Appl. No. 10/531,696
Amdt. dated December 22, 2006
Reply to Office action of September 27, 2006

AMENDMENTS TO THE DRAWINGS:

REMARKS

Fig. 1

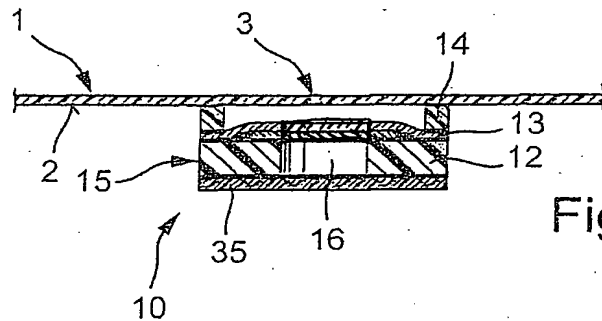
The drawings have been objected to because the passage opening (16) in the base plate is shown in Fig.1 to extend through the diaphragm (13), but Fig. 3 does not show that feature. Fig. 1 has been corrected to show that the passage opening (16) in the base plate does not extend through the diaphragm (13). In view of the correction to the drawings, withdrawal of the objection is requested.

The attached sheet of drawings includes changes to Fig. 1 and replaces the original sheet including Figs. 1-5. Fig. 1 has been corrected to show that the passage opening (16) in the base plate does not extend through the diaphragm (13).
